The Commission has issued the enclosed Amendment No. 127 to Facility Operating License No. DPR-53 and Amendment No. 109 to Facility Operating License No. DPR-69 for the Calvert Cliffs Power Plant, Unit Nos. 1 and 2, respectively. The amendments consist of changes to the Technical Specifications (TS) in response to your application transmitted by letter dated October 1, 1986, as supplemented by your submittals of March 13, March 19, April 17 and May 4, 1987. Additionally, a minor clarifying change was made in TS 3/4.1.3 with your staff's consent. This change was included in the associated Federal Register Notice of Consideration and proposed determination of no significant hazards.

These amendments 1) modify TS 3/4.1.3, "Movable Control Assemblies" by lengthening the response time and increasing the maximum reactor thermal power limit for control element assembly misalignments of greater than fifteen inches and 2) extend the response time for containment purge valves isolation on a containment radiation-high signal as specified in TS Table 3.3-5, "Engineered Safety Features Response Times," to less than or equal to seven seconds. In addition, several administrative changes were mad

FIGURE 3.1-3

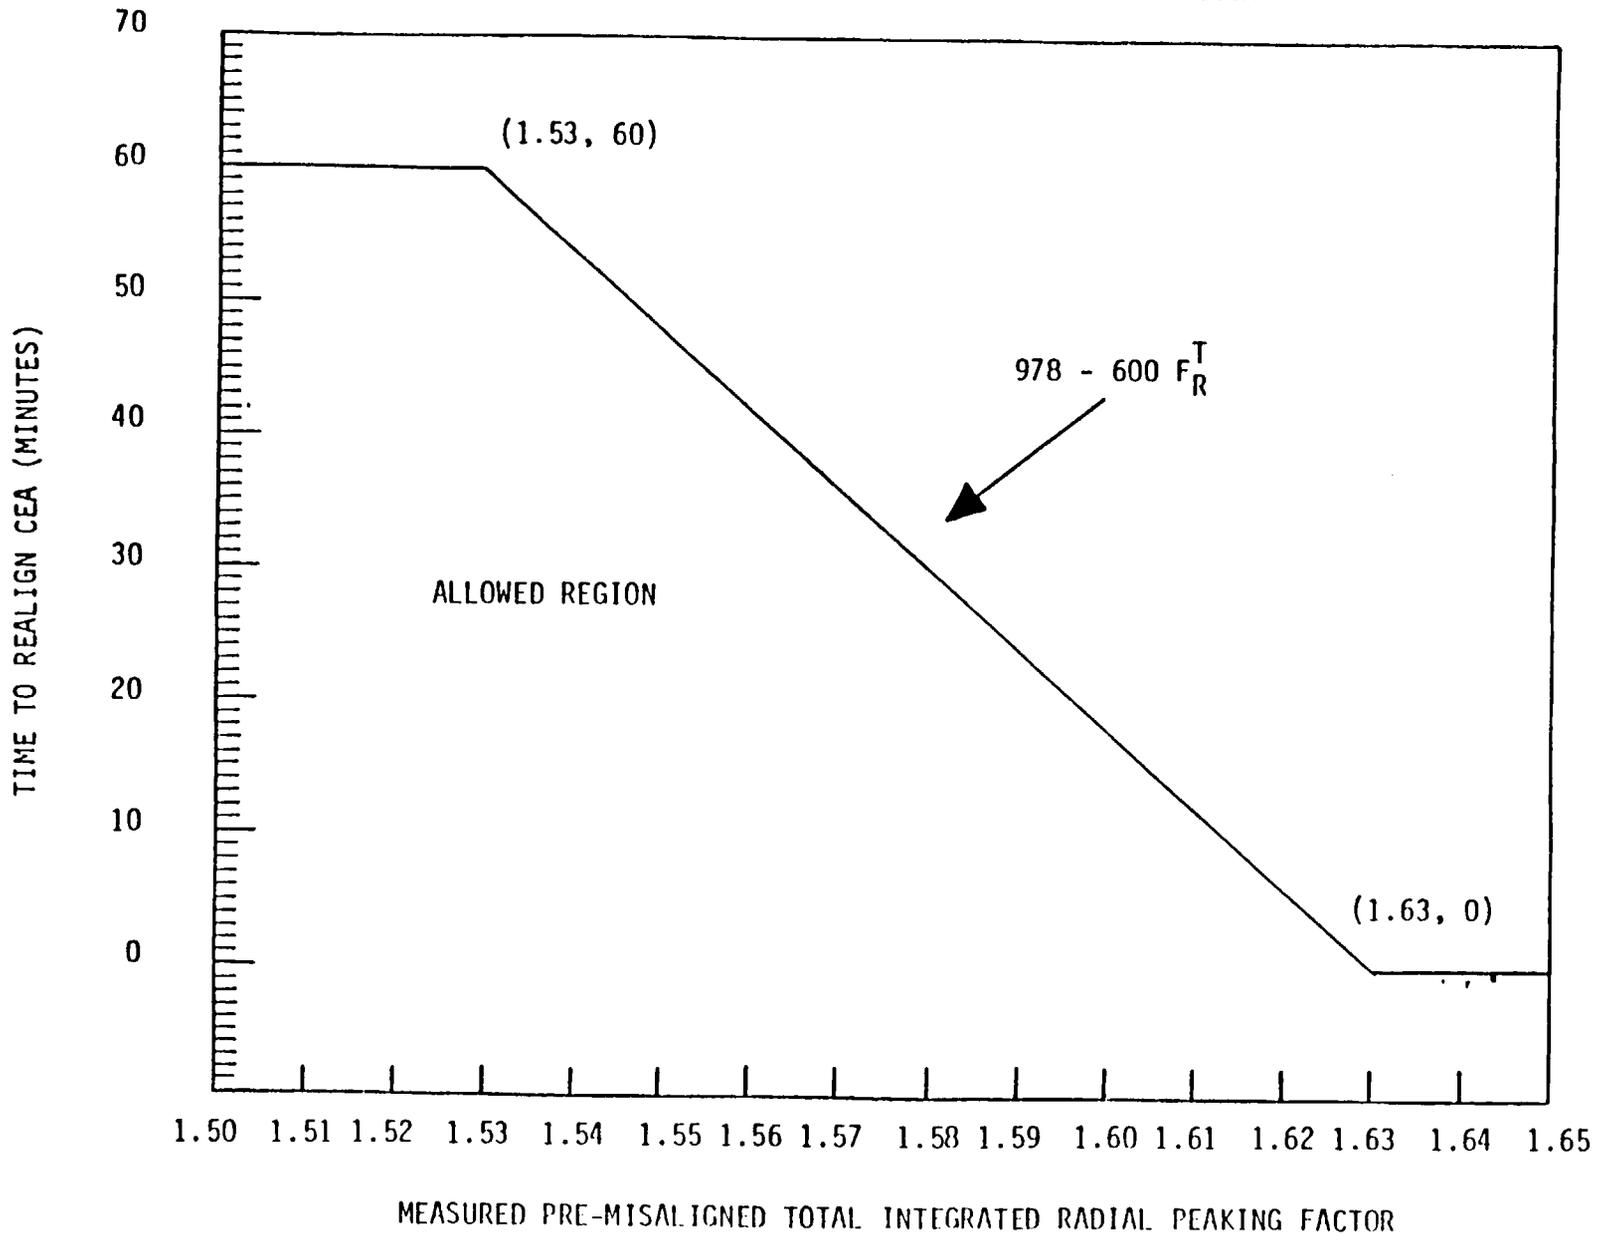
The licensee has proposed to incorporate the Figure 3.1-3 into the Calvert Cliffs Technical Specifications which shows the allowable time to realign a dropped CEA as a function of the initial value of F.T. The figure requires a reduction to 75% of the power level prior to the CEA drop within one hour when the pre-drop value of F.T equals or exceeds 1.63. As the misalignment value of F.T decreases to 1.55, operation at full power for up to one hour is allowed before a power reduction is required. Based on the CEA drop analyses performed by the licensee, the staff finds this acceptable.

- g. With one CEA misaligned from any other CEA in its group by 15 inches or more at the conclusion of the time allowance permitted in Figure 3.1-3, immediately start to implement the following actions:
